HALIFAX HARBOUR SOLUTIONS PROJECT ENVIRONMENTAL SCREENING ADDENDUM 2

**HALIFAX HARBOUR SOLUTIONS PROJECT
ADDENDUM NO. 2
RESPONSE TO FEDERAL COMMENTS**

PROJECT NO. NSD13960-6027

May 30, 2002

BARRINGTON STREET
PLAN / PROFILE
STA. 0+000 TO STA. 1+700
Drawing No
HX-01-C-1002

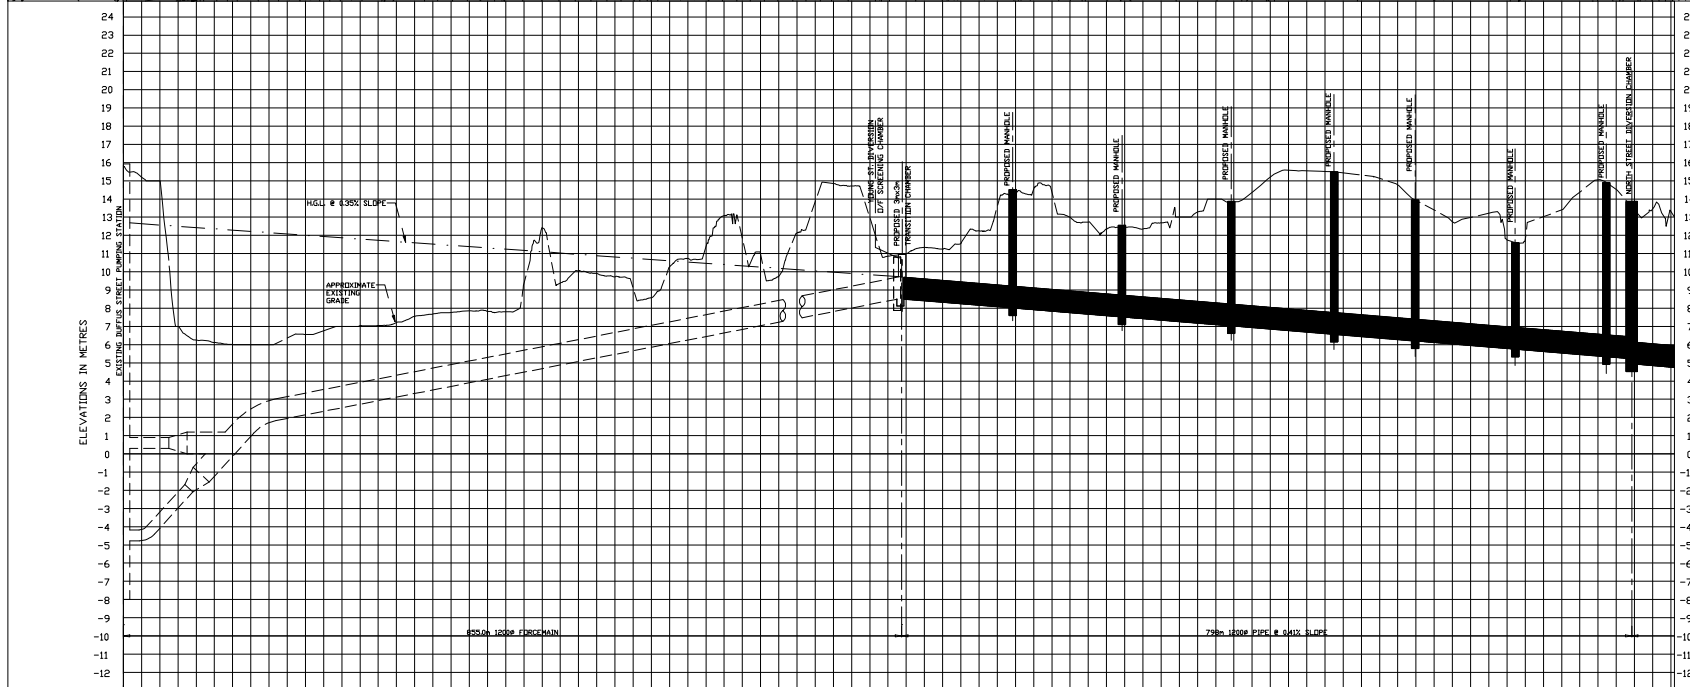
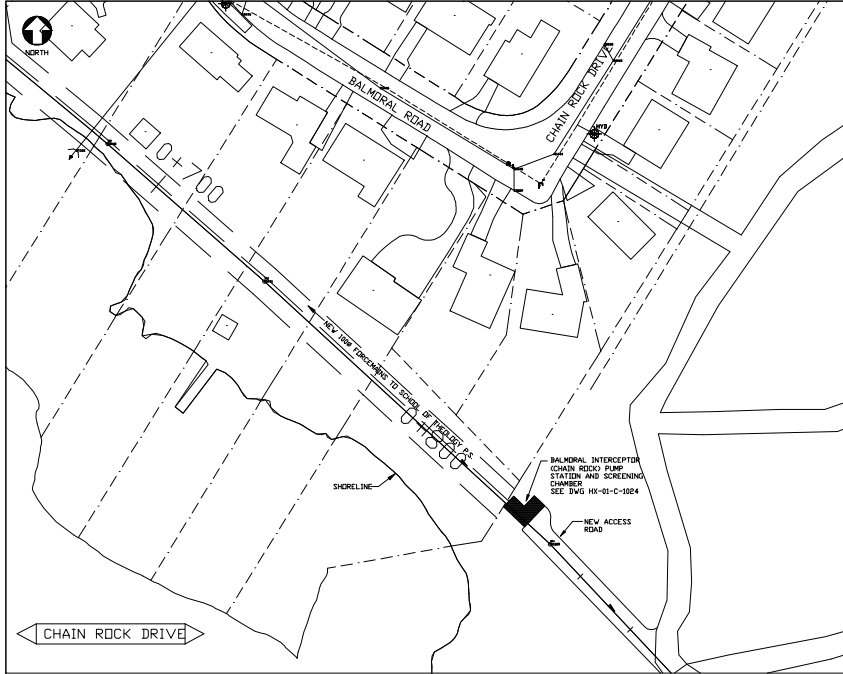
Exact location of project components on DND land is still unknown.

These negotiations have included discussions on the location of the necessary sewer line required by HRM. Since then several changes have been made to the proposed routing at DND's request. The attached drawings (HX-01-C-1002 and HX-01-C-1003 in Appendix B) detail the latest version of this routing; it is HREP's understanding that this routing is mutually acceptable to both DND and HREP. Similarly, the requirements for siting the Jamieson Street Pumping Station and diversion piping are shown on attached drawing DT-01-C-2007 (amended to show only the Jamieson Street works) (Appendix B). A letter of intent between DND and HREP is presently being finalised.
